# VILLAGE OF ELM GROVE

**3. Item 3. Review and act on a request by Edward and Amy Zosel, 2075 Elm Tree Court, for a new home.**

**PLAT OF SURVEY/GRADING PLAN**  
 FOR: BARENZ BUILDERS RE:ZOSEL  
 LOT-12 BLOCK-A ELM GROVE HIGHLANDS  
 VILLAGE OF ELM GROVE, WAUKESHA COUNTY, WISCONSIN

Re: 2075 Elm Tree Court  
Redevelopment Plan Review

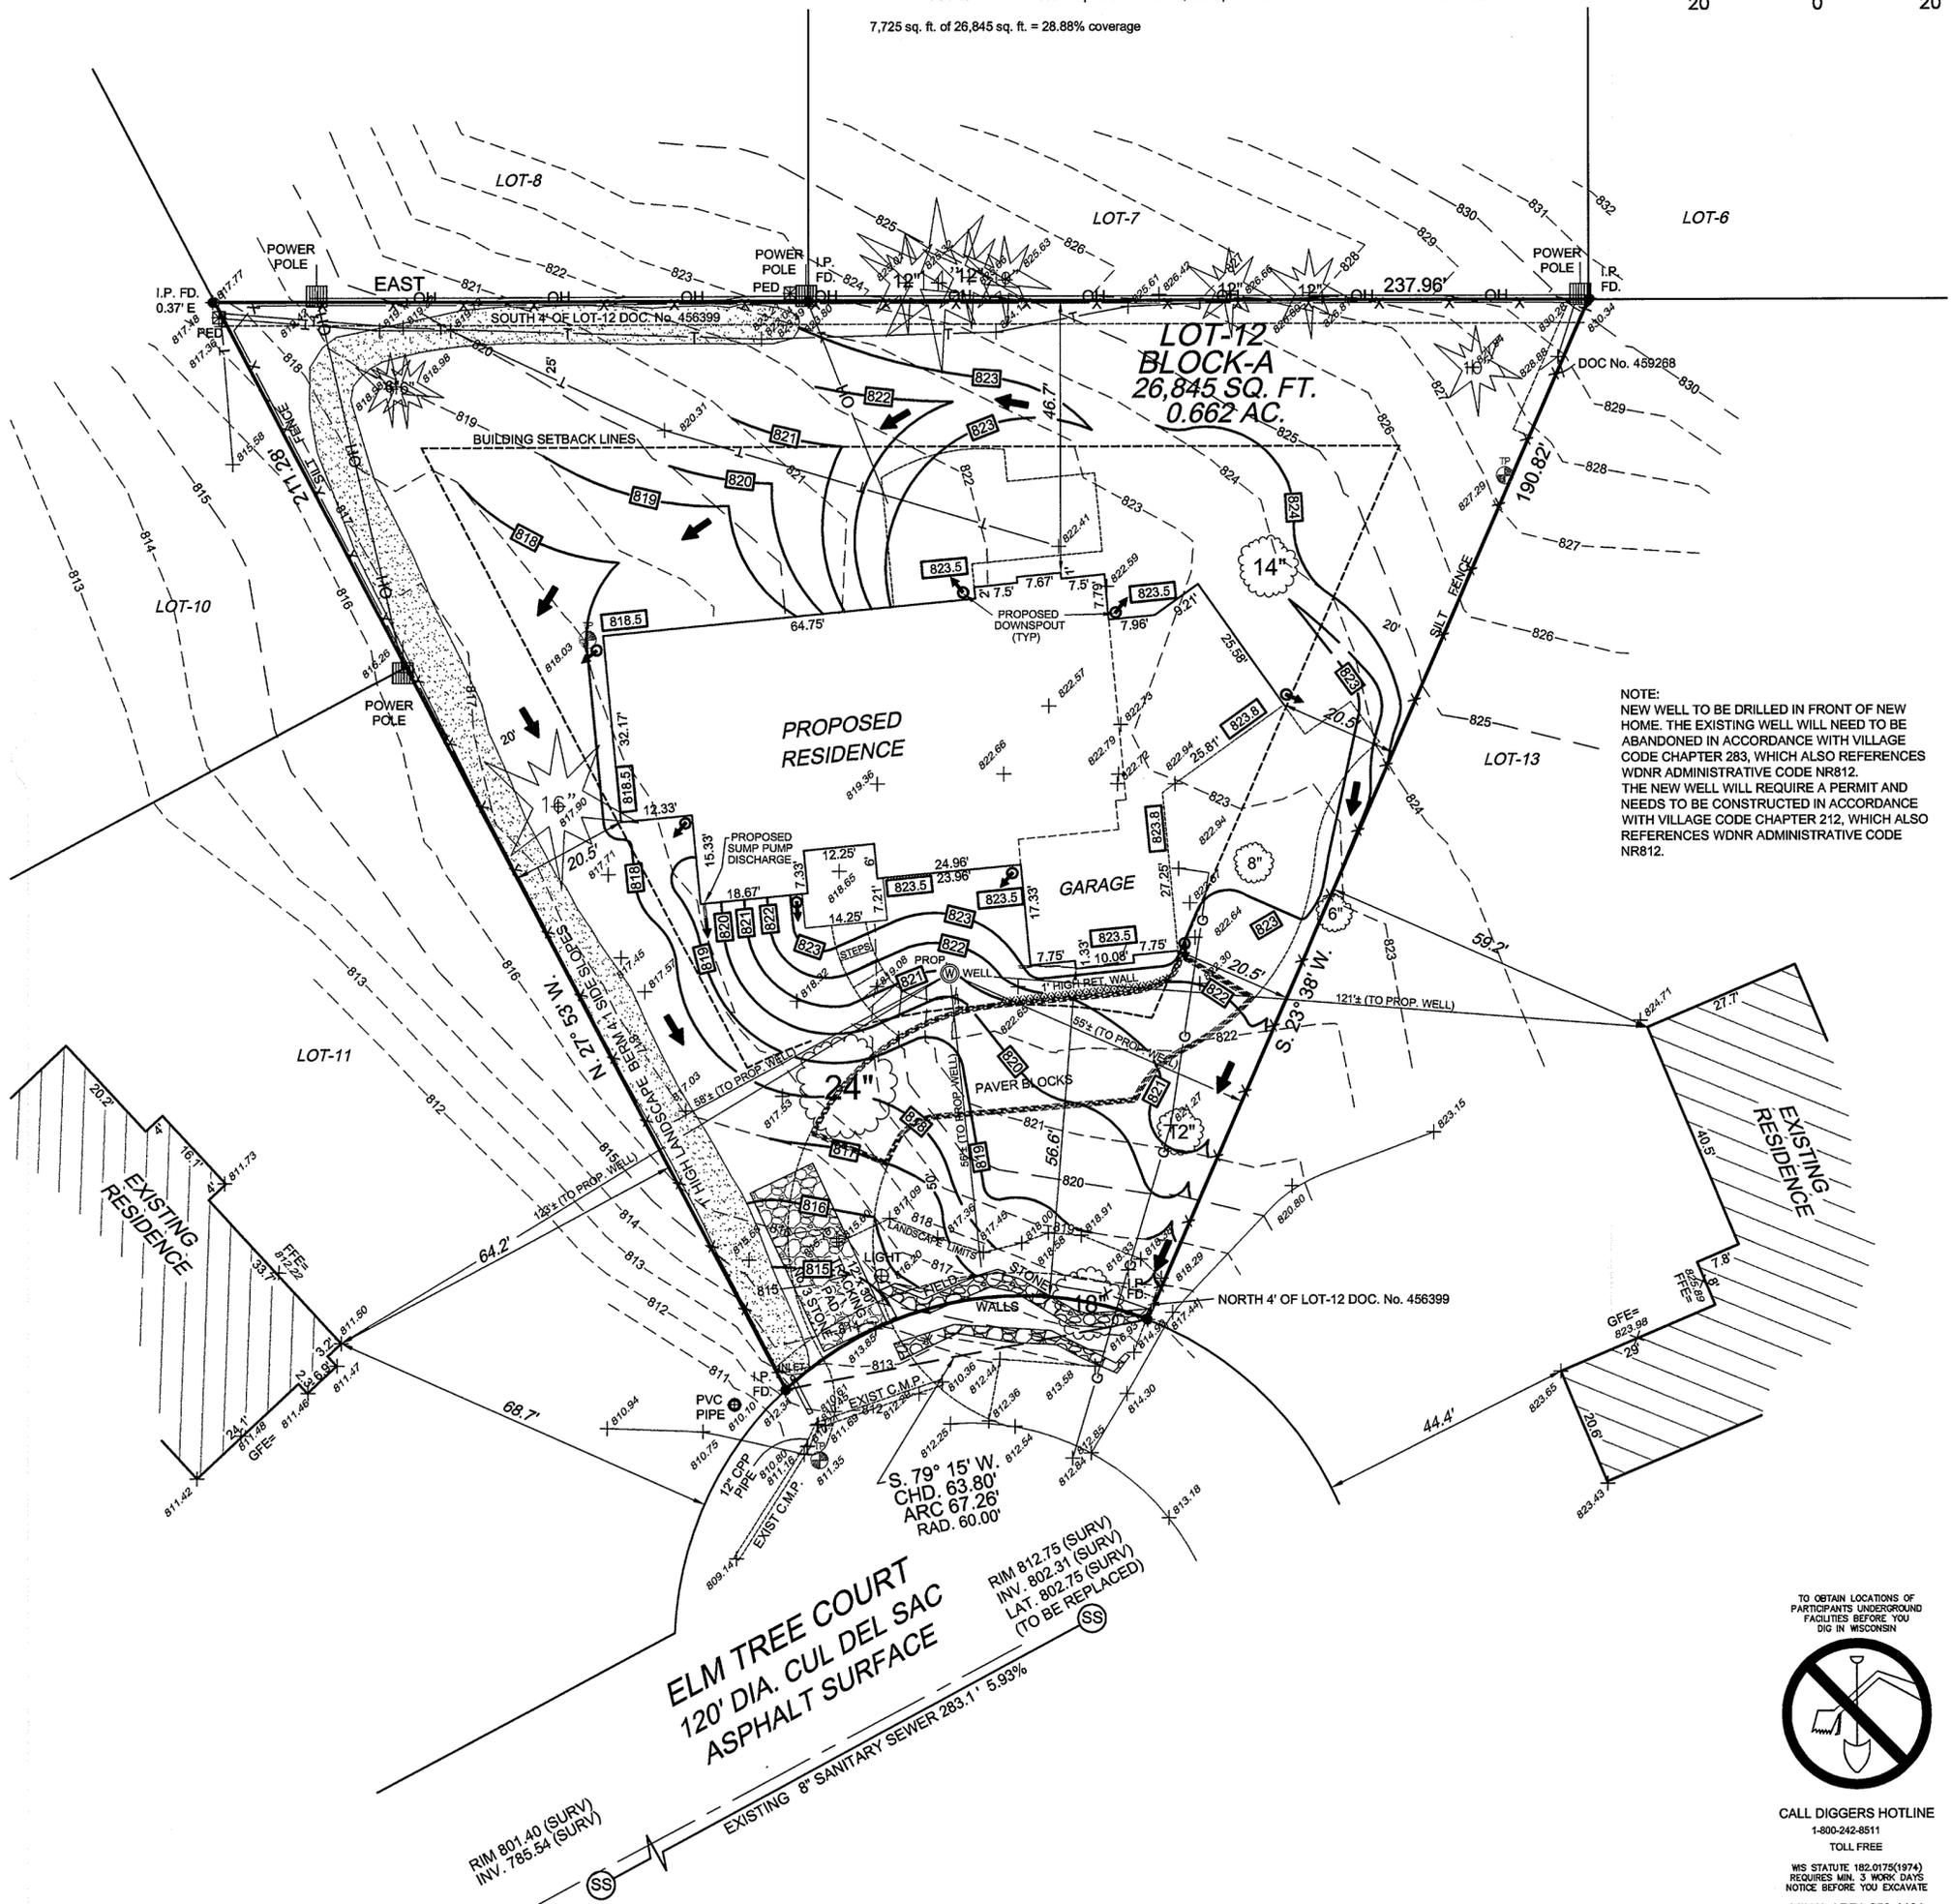
1. The following information must be added to the Plat of Survey:
  - a. Proposed garage floor elevation.
  - b. Label the existing sanitary sewer main as an 8-inch diameter pipe in accordance with record drawing.
  - c. Distances from proposed well to adjacent structures and lot lines.
  - d. Direction of discharge from proposed downspouts.
  - e. Proposed sanitary lateral, gas, electric and telephone utilities that will serve the new home.
  - f. Impervious area calculations of the existing site development and as proposed.

3. Water: The Plat of Survey shows a new well to be drilled in front of the new home. The existing potable well will need to be abandoned in accordance with Village Code Chapter 283, which references WDNR Administrative Code NR812.

The Erosion Control plan provided with the demolition application shows silt fence to be installed around the perimeter of the property. The silt fence cannot be installed within the public right-of-way and should be moved south to the property line.

A 30-foot long tracking pad consisting of 3-inch breaker run stone in the new driveway near the road must be added to the Erosion Control plan.

Impervious area calculations and gross lot size were not provided with the submittal. It is unknown if the proposed redevelopment plan meets building footprint and impervious area limitations set by Chapter 335 of the Village Code.

The Plat of Survey shows the proposed driveway having slopes in excess of 14% and up to 20% in one location. Driveways with slopes greater than 10% are considered steep and in general undesirable. The applicant should consider revising the grading plan to make driveway slopes more desirable.

The Plat of Survey shows the proposed sidewalk leading up to the front door having a slope of 20%. Sidewalk ramps as defined by ADA are typically limited to a slope of 8.33% (1:12). ADA accessible sidewalk runs are limited to a 5% slope unless proper landings are provided. Even though revisions may not make the sidewalk ADA accessible, the applicant should consider revising the grading plan to make the sidewalk slope more desirable.

Topographic contours show that storm water runoff from the southwest part of the lot is directed onto the neighboring property to the west. Since the proposed redevelopment is likely to direct more runoff toward the neighboring property than under existing conditions, the grading plan must be revised to keep storm water runoff on the applicant's property.

The Plat of Survey shows a swale to be constructed around the south side of the proposed house directing storm water runoff toward the east. The Plat of Survey also

shows a landscape berm will be constructed along the east property line. The grading plan must be revised to show the height of the berm will be adequate to intercept the runoff from the swale and direct the flow to the Elm Tree Court right-of-way. The berm will also need to be extended at both ends so that runoff does not flow onto the neighboring property. An inlet should be provided between the two driveways to allow the runoff to enter the culvert rather than flow across the neighboring driveway.

The Plat of Survey shows some proposed contours having slopes that are 3:1. We recommend vegetated slopes be 4:1 slope or flatter to make initial restoration and future maintenance by the home owner easier. Therefore, we recommend the grading plan be revised to provide slopes that are 4:1 or flatter when possible.

The Plat of Survey shows the first floor elevation of the new house will be at elevation 825.8. The first floor elevation of the new home:

- is approximately 1.7 feet higher than the first floor elevation of the existing home on the lot.
- is approximately 13.5 feet higher than the edge of pavement in the cul-de-sac.
- is approximately level with the first floor elevation of the neighboring home to the west.
- is approximately 13.5 feet higher than the first floor elevation of the neighboring home to the east.

The first floor elevation is set at an elevation that will provide a 7 foot lower-level exposure on the east side of the new home. The first floor elevation may need to be lowered to resolve sidewalk/driveway slope and drainage issues discussed in other comments. Regardless, the Building Board will need to review the house grade from an aesthetic point of view.

Based upon the above issues, we recommend the Plat of Survey and Erosion Control plan be revised and resubmitted before it is approved by the Village. Please contact our office with any questions regarding this matter. Thank you for allowing us to be of service to the Village of Elm Grove.
